Boston Alternative Energy Facility

Response to Environment Agency's queries on Critical Infrastructure and Levels across the Application Site

Document Reference: 9.40

Subject: Boston Alternative Energy Facility Examination: Deadline 3 Response to Environment Agency queries on Critical Infrastructure and Levels across the Application Site

TITLE
**BOSTON ALTERNATIVE ENERGY FACILITY
 DEVELOPMENT CONSENT ORDER
 Regulation 5(2)(c) - Deadline 3 Identification of Critical Infrastructure Plan
 BOSTON BOROUGH COUNCIL
 SHEET 1 OF 1**

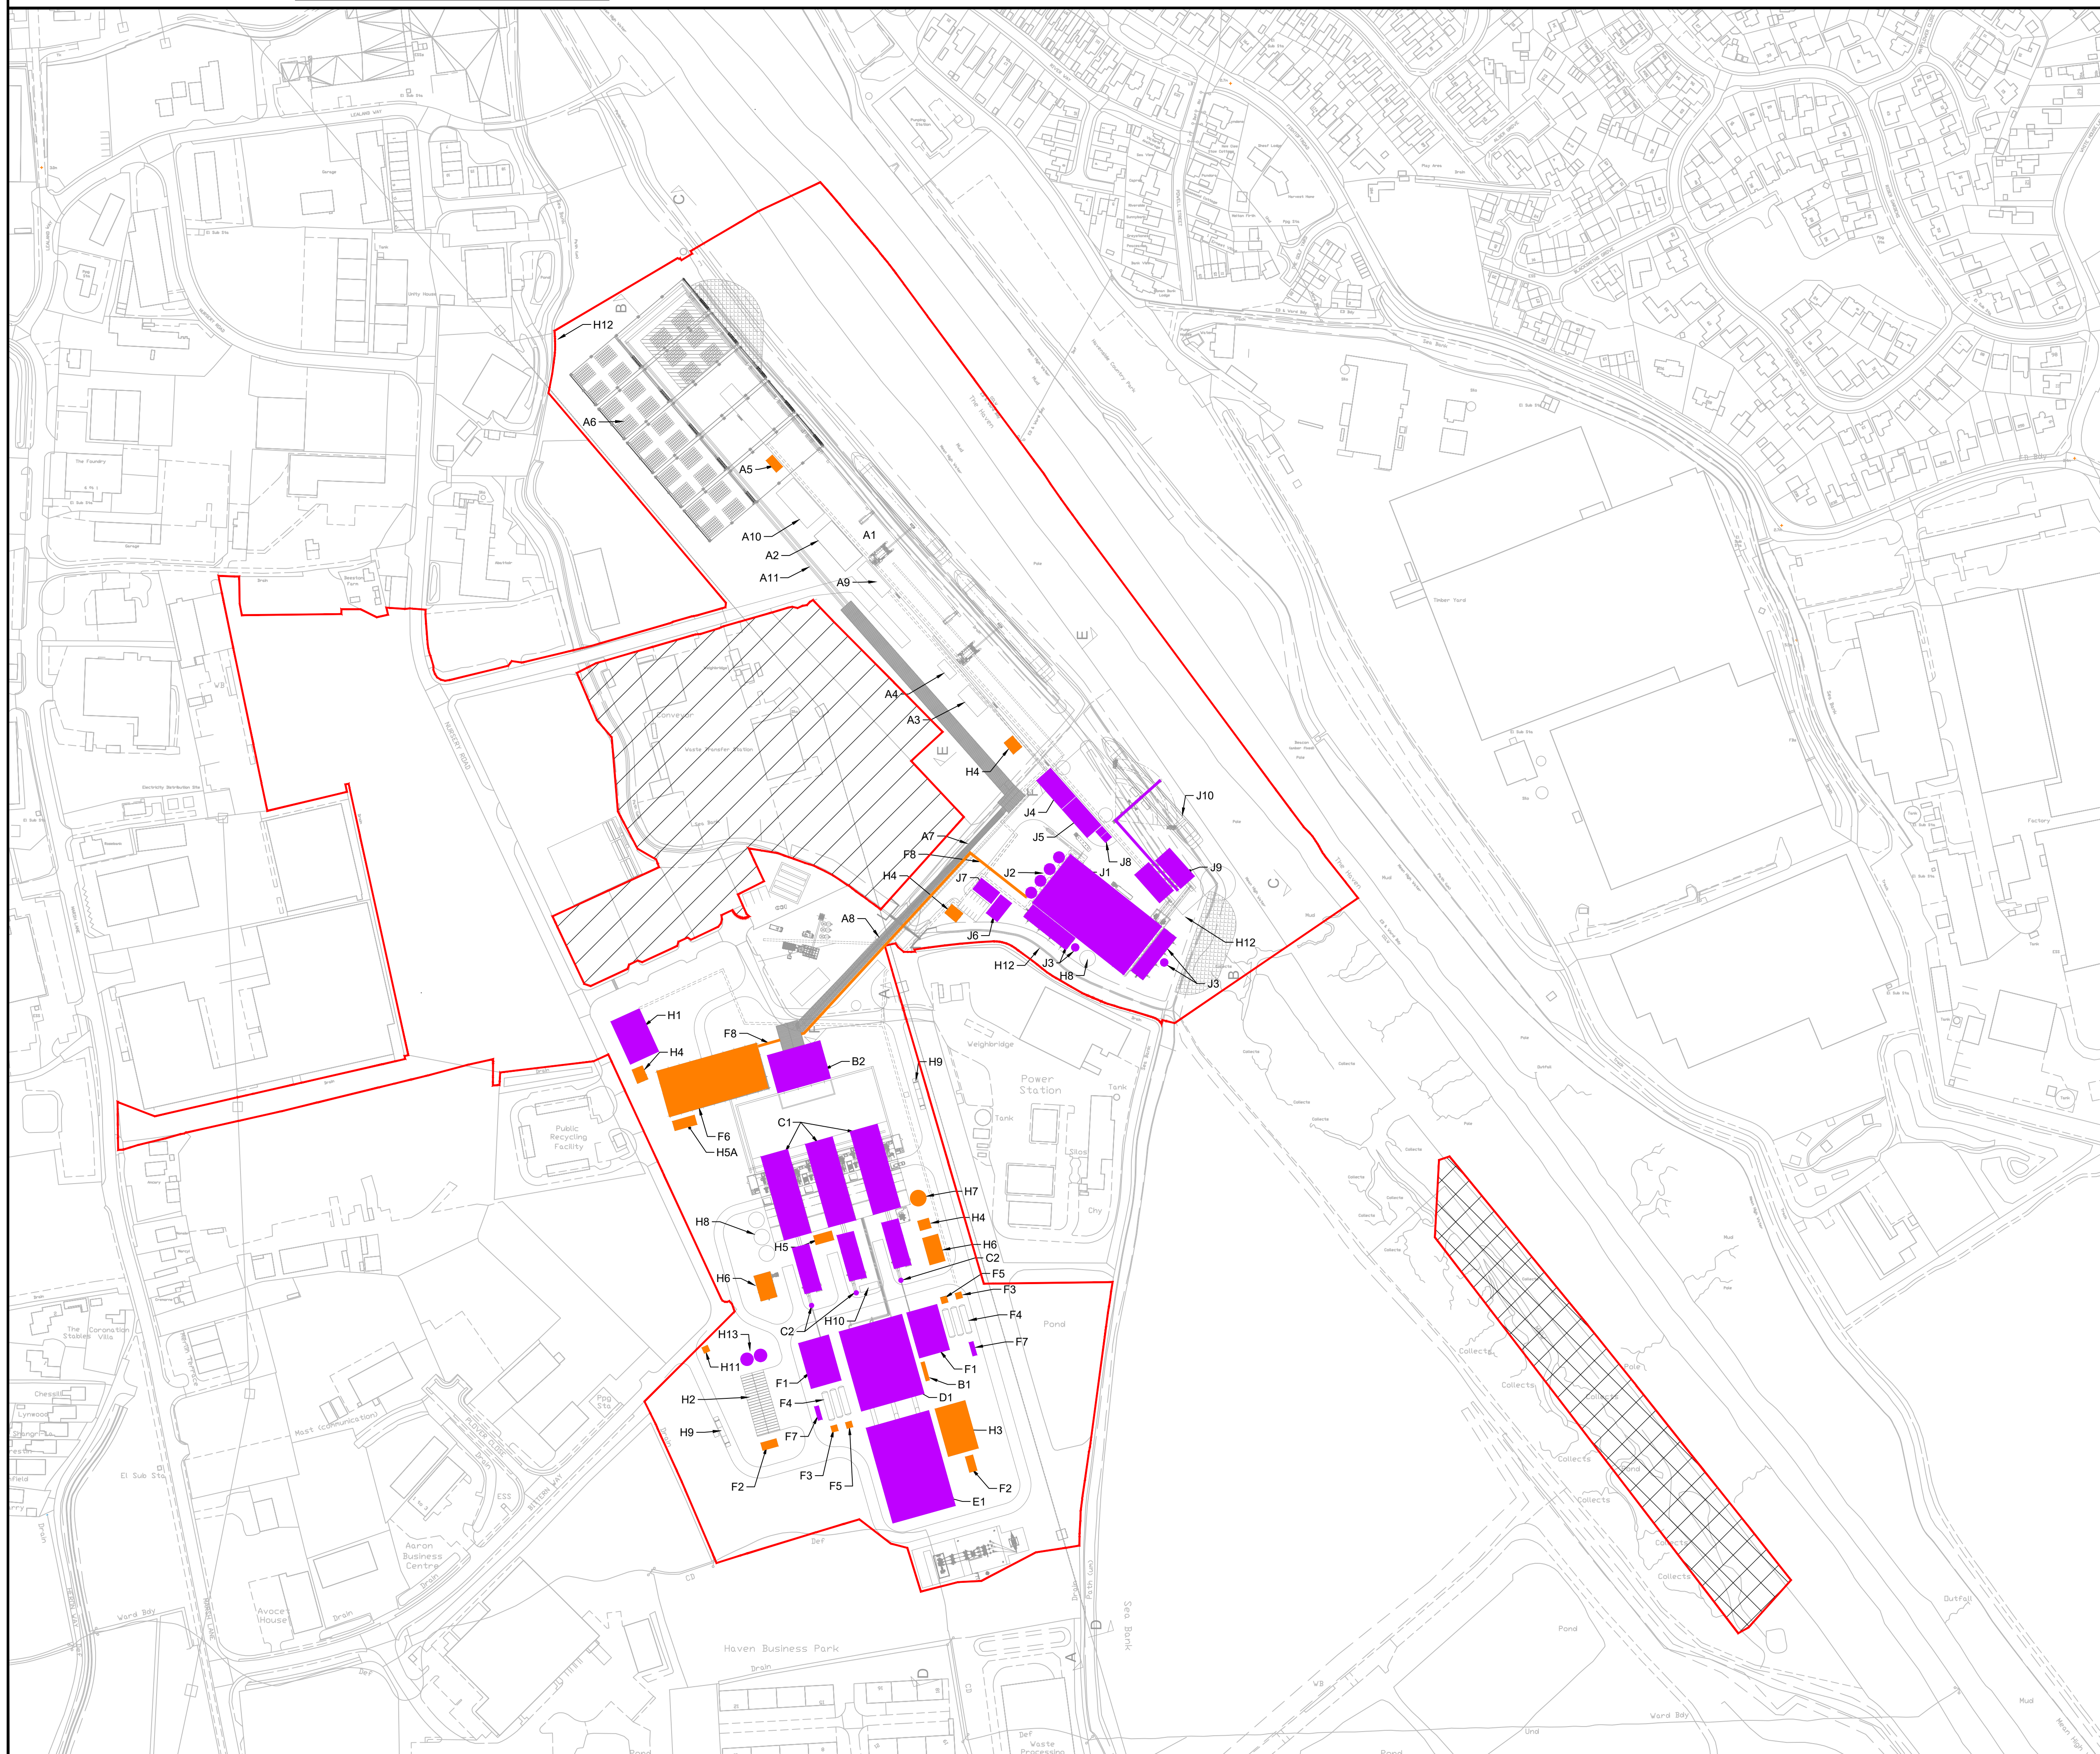
- 3.4 *Notwithstanding paragraphs 13.1.127 to 13.1.133 of the FRA (document reference 6.4.13, APP-106), we do not consider that the impacts of flooding on any critical infrastructure within the site has been adequately considered. We require further clarification about what aspects of the development are considered critical, and what mitigation measures are in place to protect them. We recommend that any features considered to be critical infrastructure should be raised above the predicted flood level to ensure it is protected in the event of a flood.*

To aid in the clarification required by the Environment Agency, a summary of the main buildings and elements of the Facility is provided in **Table 1**, including whether they are classed as ‘critical infrastructure’, ‘significant infrastructure’ or ‘other’ and also their siting level in comparison with the maximum water level. These elements are also shown on Drawing Number PB6934-RHD-01-ZZ-DR-4030 entitled Regulation 5(4) – Deadline 3 Identification of Critical Infrastructure Plan accompanying this Technical Note. Where indicated in **Table 1**, key equipment will be installed either on plinths or from support steelwork, as applicable, to remain above the maximum water level.

It can be seen from the information presented in **Table 1** that all elements of the Facility which are classed as ‘critical infrastructure’ (highlighted in red) have been sited such that equipment is located above the 1 in 200 year maximum water level. This aligns with guidance set out in the Planning Policy Practice Guidance (Department of Levelling Up, Housing and Communities, 2021) and addresses the concerns raised by the Environment Agency and their recommendation with regard to the setting of critical infrastructure above the predicted flood level.

Based on the above, in response to the concerns expressed in Paragraph 3.4 of the Environment Agency’s Written Representations (REP1-051), the Applicant believes that the impact of flooding on critical infrastructure elements has been adequately considered. By adopting raised levels for these elements the Applicant notes that sufficient mitigation measures have been included within the design and operating philosophy to ensure that the Facility will be protected from potential damage, should there be a breach in the flood defences during an event.
